3G CHANGE REQUEST

23.060 CR prov1

Source: Nokia **Date:** 20/08/1999

Subject: MM states in UMTS

MM States in UE

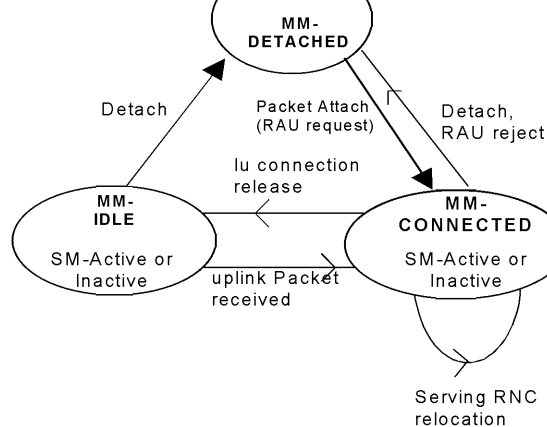
Reason for change: The MM states are not yet described in 23.060. This contribution proposes to add them. Note that some points are marked FFS, if they are linked to points under discussion.

Clauses affected: Text proposed for chapter 6.3 and 6.4

The figure below introduces the states of MM. The states and activations are further described in sub-sections.
